**TOWN OF PLYMOUTH
PLYMOUTH MUNICIPAL AIRPORT**

CONSTRUCT, MARK, AND LIGHT TAXIWAY 'E' EXTENSION (APPROX. 500' X 35')

ADDENDUM No. 3

Date: December 22, 2020

G1.3

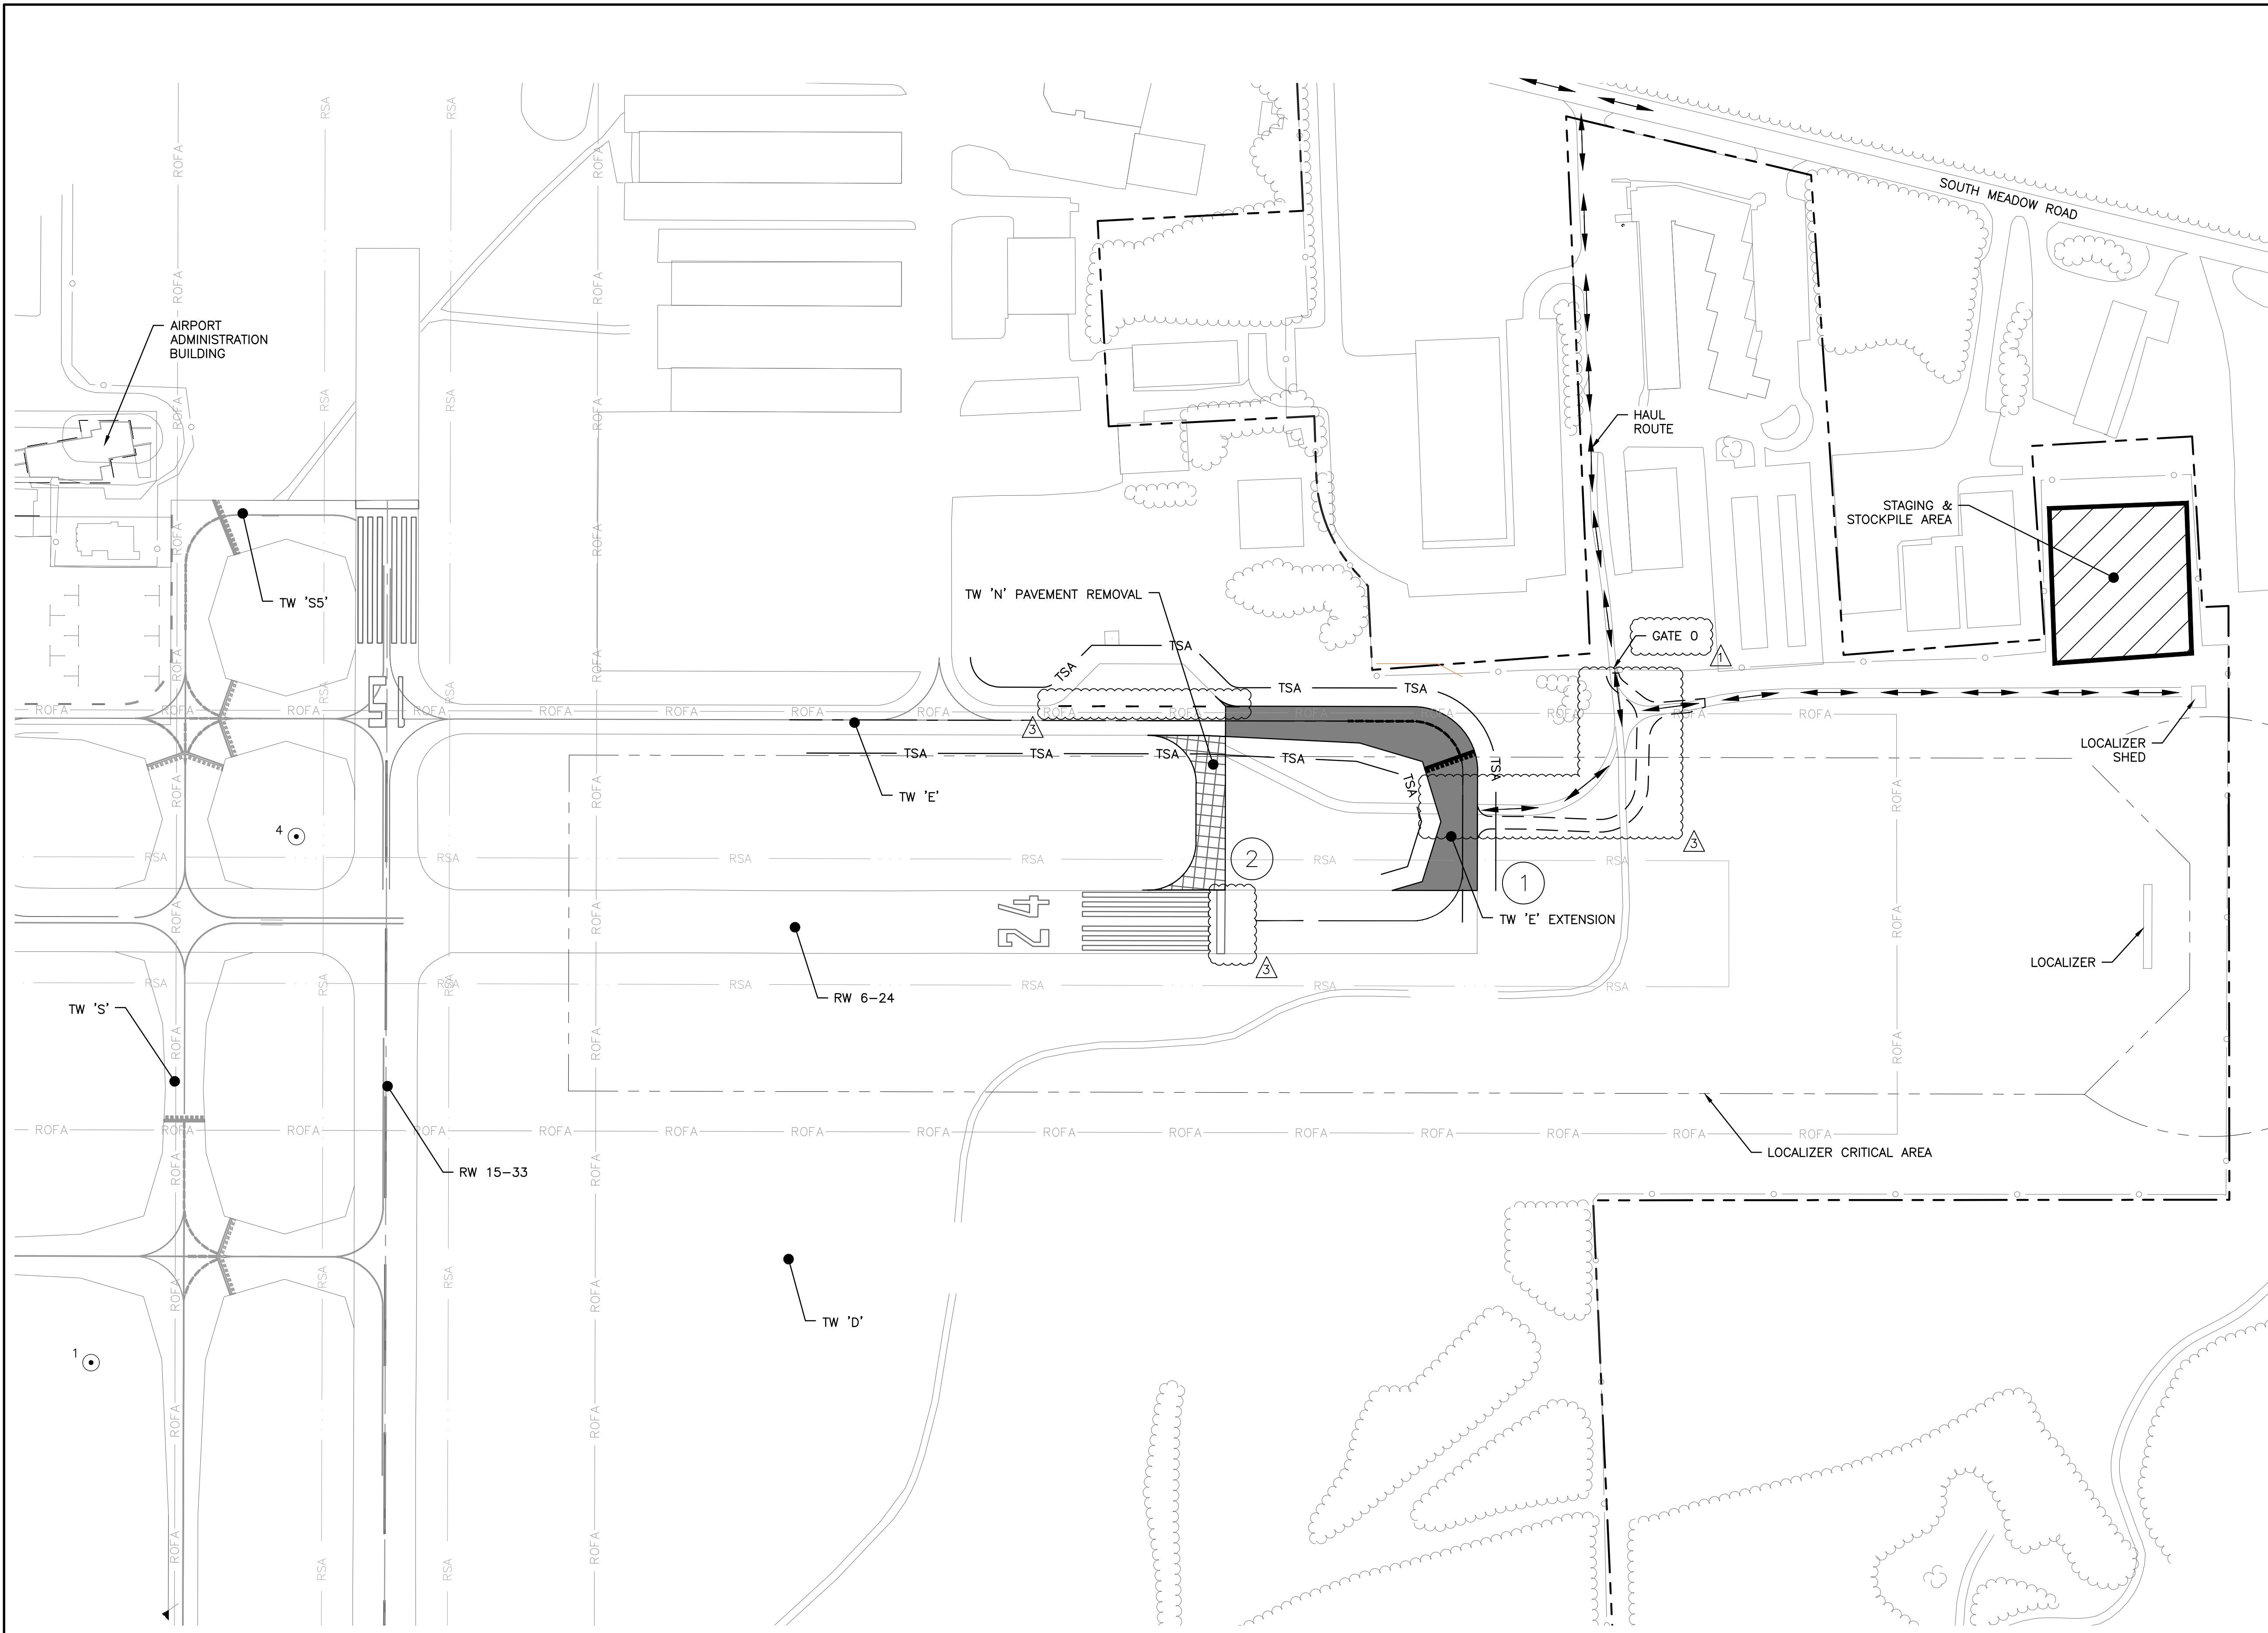
3. Drawing G1.3 has been revised to remove the previous proposed threshold light removal work on RW 6-24, and to clarify that the haul road from Gate 0 is not paved.

S1.1

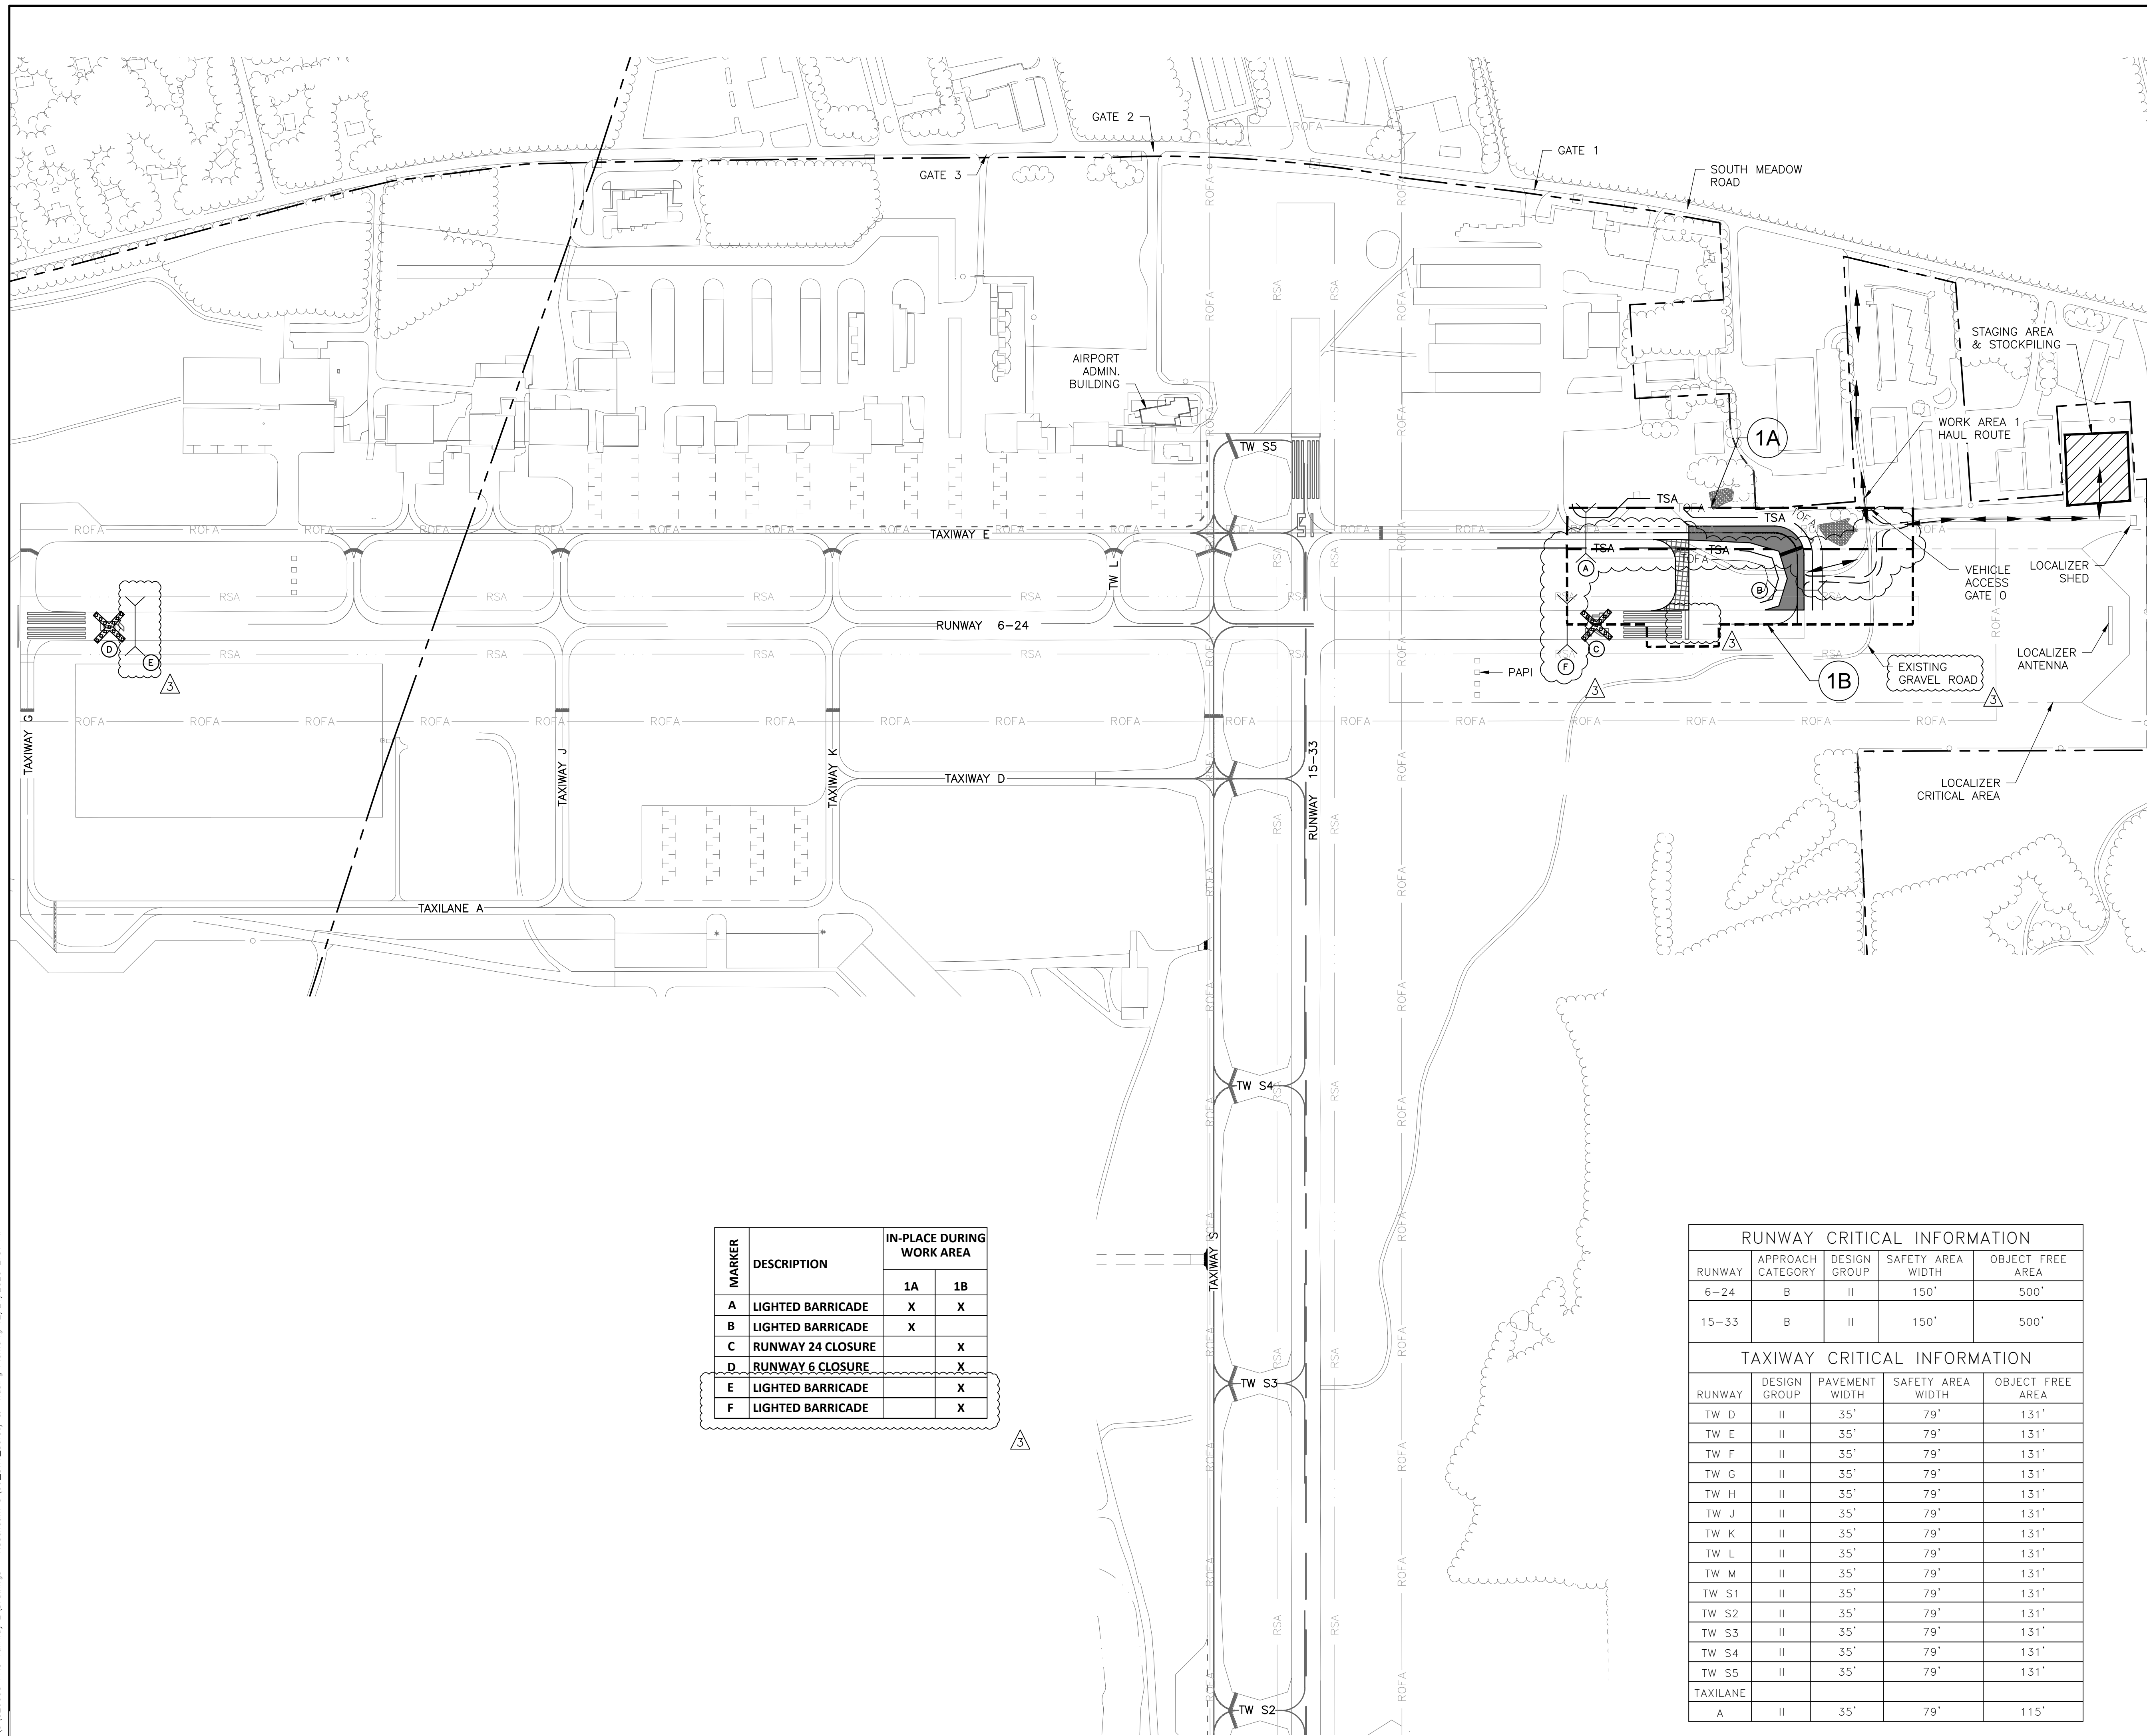
4. Drawing G1.4 has been revised to show the new bid quantities.
5. Drawing G1.5 has been revised to clarify security notes.
6. Drawing S1.1 has been revised to add lighted barricades to RW 6-24 and revise the division between Phase 1A and Phase 1B to be 200' from RW centerline.

TEMPORARY RUNWAY CLOSURE DETAIL
 N.T.S.

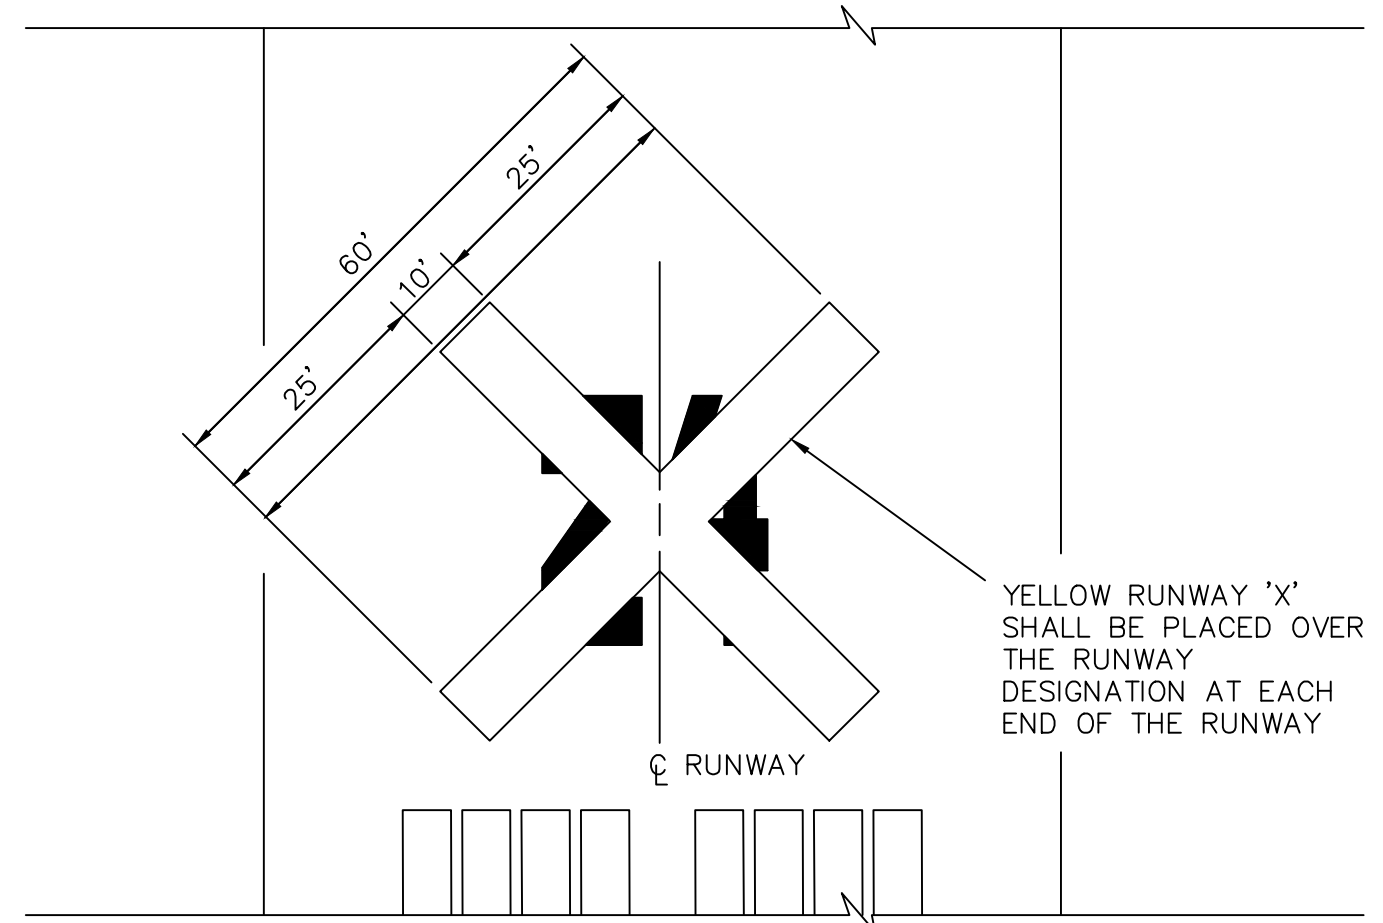
7. Drawing S1.2 has been revised to indicate that Phases 1A and 1B will be done concurrently so that the project can be completed in 45 calendar days. Additionally, the temporary runway closure detail clarifies that the contractor must use lighted closure markers for night closures.
